MOLEHILL GREEN, TAKELEY.

Note: Base plan/map produced by MSA (see detail below).
 Ecological Enhancement mark-up produced by JBA.

CLIENT:	MOLE HILL GREEN LTD.		
PROJECT:	MEADOW VIEW/THE COTTAGE MOLEHILL GREEN TAKELEY CM22 6PQ		
DRAWING:	PROPOSED BLOCK PLAN AND SITE LOCATION PLAN		
SCALE:	AS NOTED @ A1	DATE:	14.07.2023
PROJECT NO:	23-039	DRAWING NO:	200
		REVISION:	00
DESIGN - PLANNING - BUILDING REG'S

PROPOSED BLOCK PLAN
 SCALE 1:200

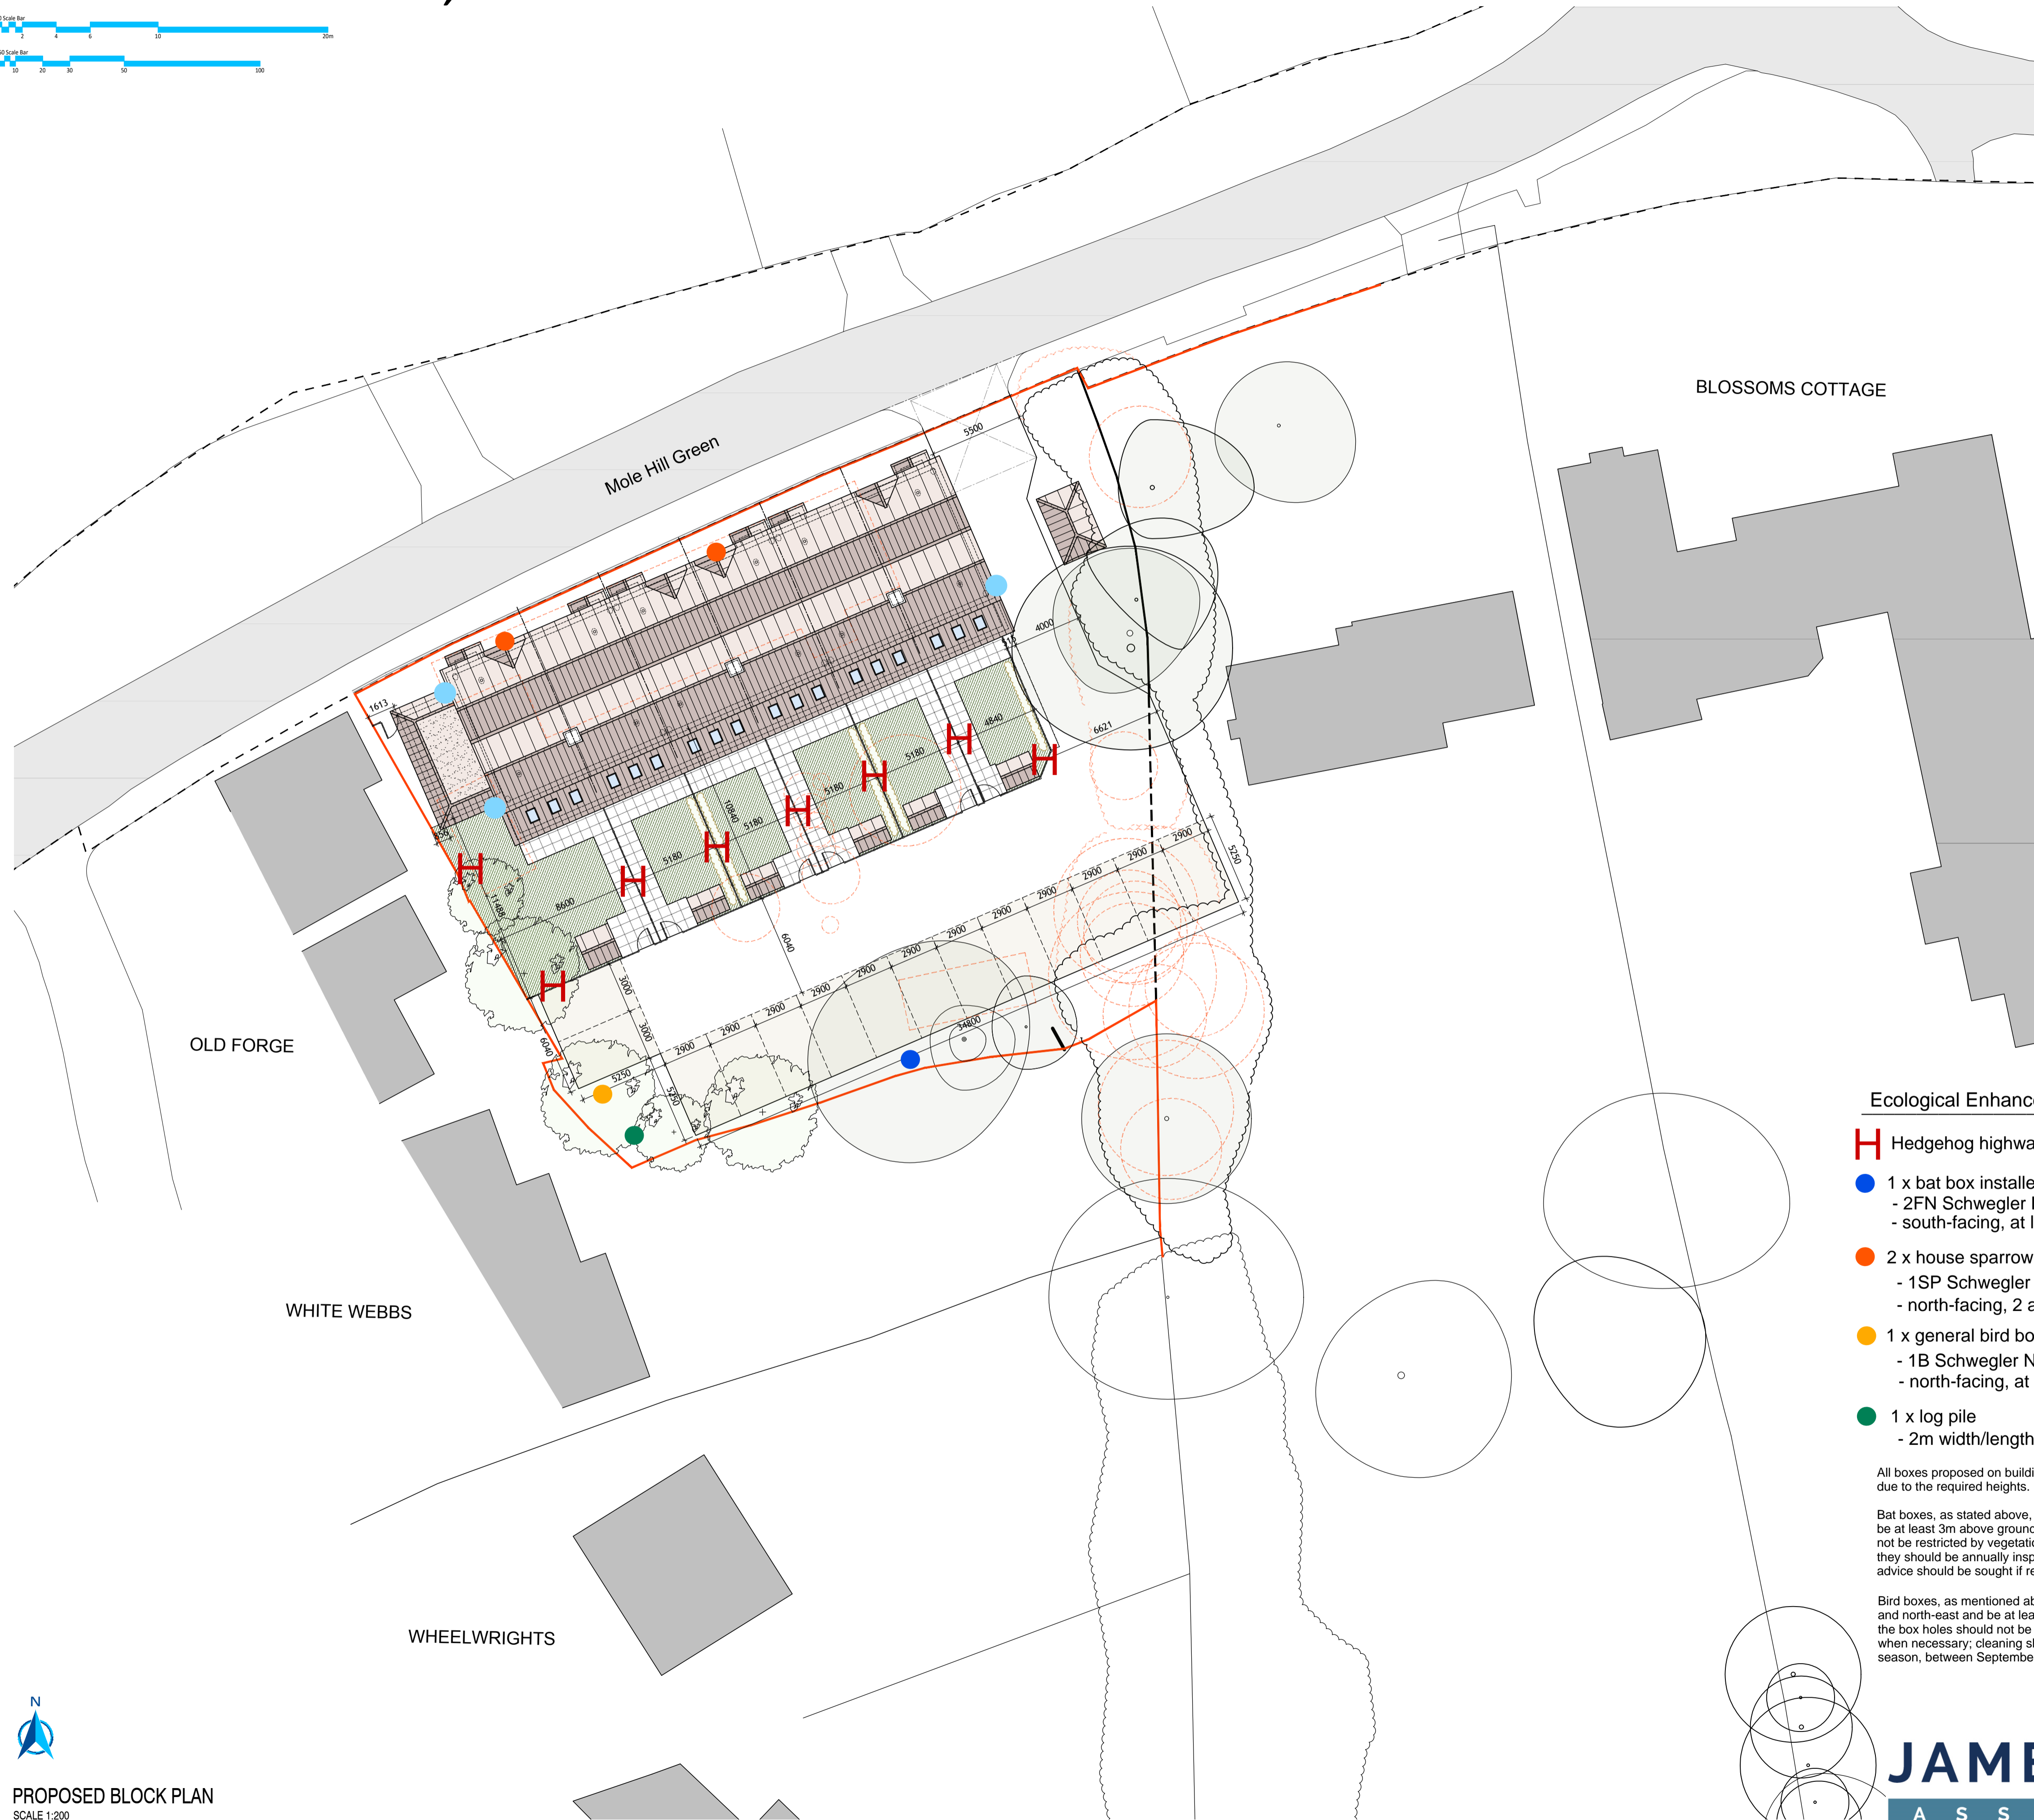
Ecological Enhancements

- H** Hedgehog highways
- 1 x bat box installed on retained tree
 - 2FN Schwegler Bat Box (or similar)
 - south-facing, at least 3m above ground
- 2 x house sparrow terraces installed on building
 - 1SP Schwegler Sparrow Terrace (or similar)
 - north-facing, 2 and 5 m above ground
- 1 x general bird box installed on retained tree
 - 1B Schwegler Nest Box (or similar)
 - north-facing, at least 2m above ground
- 1 x log pile
 - 2m width/length and 1 m in height
- 3 x integrated bat boxes on building
 - Vivara Pro Build-in WoodStone Bat Box (or similar)
 - at least 4m high, with at least 1m clear space below for safe emergence
 - away from artificial lighting

All boxes proposed on buildings should be on residential properties rather than garages due to the required heights.

Bat boxes, as stated above, should be positioned between south-east and south-west, be at least 3m above ground and away from artificial lighting. Additionally, boxes should not be restricted by vegetation. The suggested bat boxes above are 'self-cleaning' but they should be annually inspected for damages and replaced when required. Ecologist advice should be sought if replacement boxes are required.

Bird boxes, as mentioned above, should be positioned between north-west and north-east and be at least 2m above ground. Additionally, entrances to the box holes should not be restricted. Boxes should be inspected and cleaned when necessary; cleaning should be undertaken outside the breeding bird season, between September and February.
